JH900-A1: 900 ZXI OIL PUMP BLEEDING, ENGINE FASTENER TIGHTENING		JS 95-05 April 12, 1995
---	---	---	-----------------------------------

FACTORY DIRECTED MODIFICATION

All 900 ZXI watercraft produced through H.N KAW43438C595 need oil pump bleeding and either Repair A or B shown below, depending on eligible Hull Identification and Engine Number ranges. Follow this flow chart to be sure that each unit gets the appropriate repairs. Failure to repair can result in engine seizure.

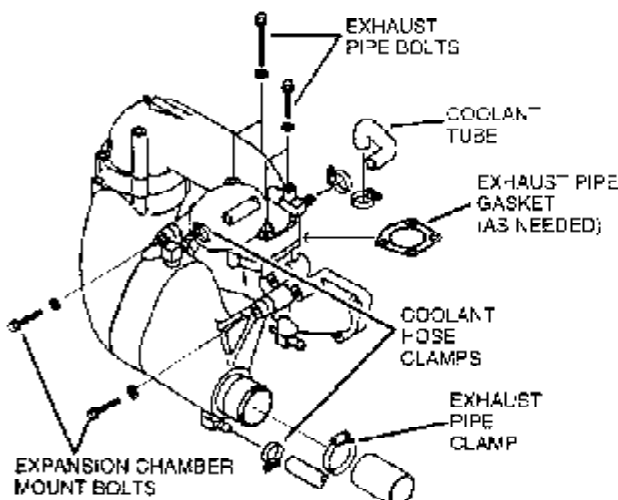
- Loosen the clamps for the two coolant hoses on the chamber, and pull the hoses loose.
- Loosen the clamp at the expansion chamber outlet for the exhaust pipe to the water muffler.
- Remove the coolant tube between the cylinder head and the exhaust pipe.
- Take out the four bolts holding the exhaust pipe to the exhaust manifold.

- Remove the two expansion chamber mounting bolts.
- Protect the front end of the engine with a soft cloth, and shift the exhaust pipe and expansion chamber toward the front of the craft, out of the way.
- One by one, loosen and then retighten each of the cylinder base nuts to the specified torque.

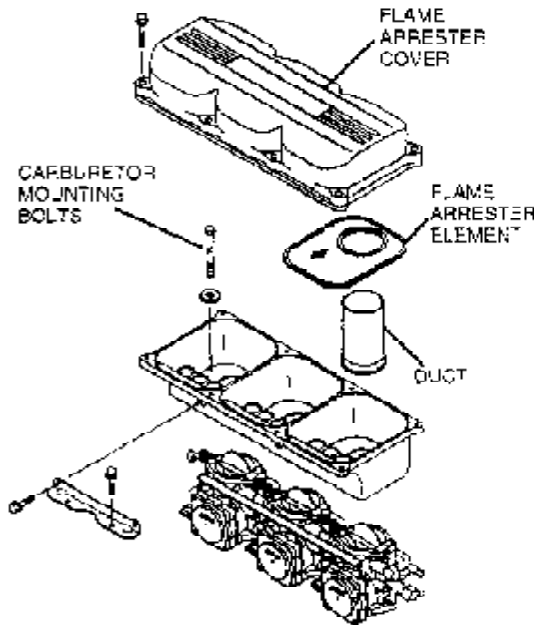
- o *Using a non-permanent locking agent as above, tighten the carburetor mount bolts to the specified torque.*

Carburetor Mount Bolt Torque

0.9 kg-m (78 lb-in)

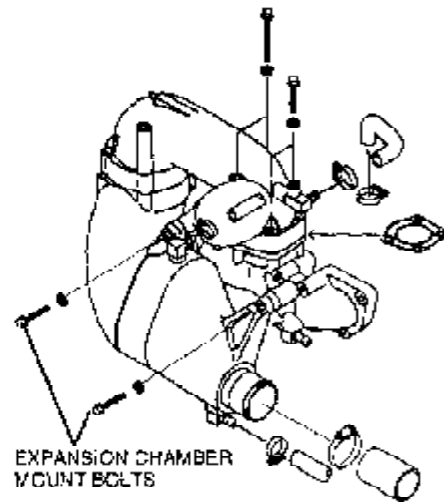
- Tighten the mounting bolt to the specified torque.

Carburetor Mounting Bolt Torque

0.9 kg-m (78 lb-in)
